Ref: 21-0141P/04

RE: Request to Change a Development Approval (s78 of the Planning Act 2016)  
Material Change of Use and Building Work for Multiple Dwelling (A006643329)  
23, 25 & 27 Maud Street, Newstead QLD 4006 (Lots 71 – 73 on RP9348)

# Minor Change Application

**Table C – Comparison of Landscaping**

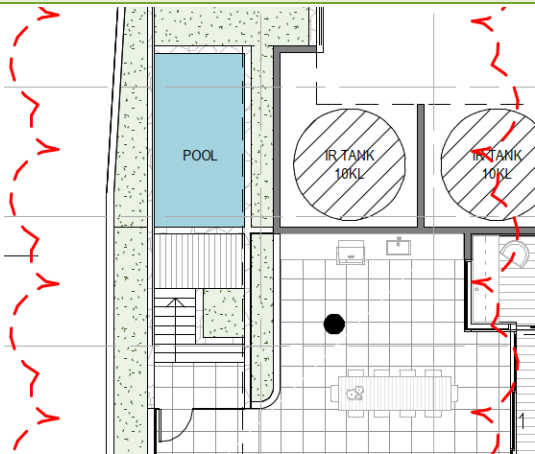
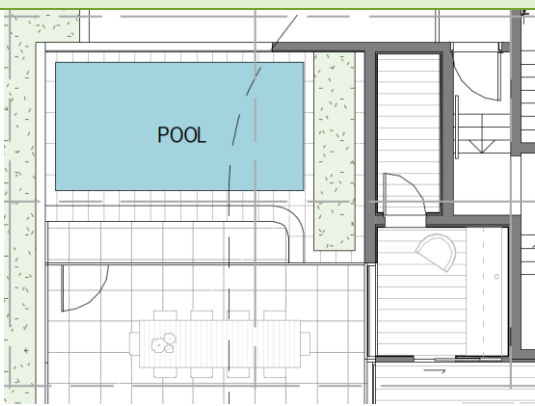
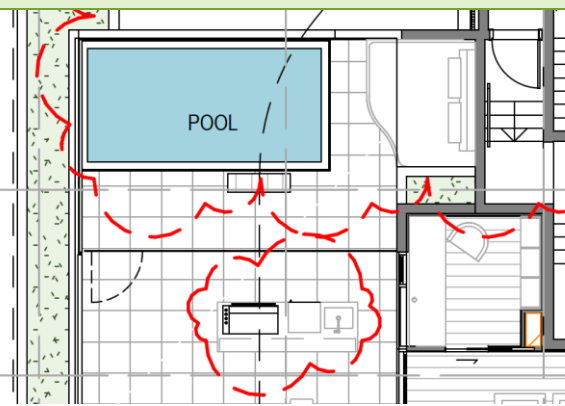
Minor changes are proposed to landscaping located on the Sub-penthouse and Penthouse levels, shown in **Table C** below. The proposed changes are as follows:

- **Sub-penthouse level:** Additional planting has been included next to the external stairs which lead to the pool. The additional planting increases the total landscaped area by approximately 1.5m<sup>2</sup>.
- **Penthouse level:** The containerised planting which adjoins the pool has been removed and relocated to abut an apartment wall. The relocated containerised planting has an area which is approximately 2m<sup>2</sup> less than the approved Landscape Concept Plan.
- The landscaping located on Ground level – Level 9 is as per the approved Landscape Concept Plan and no changes are proposed.
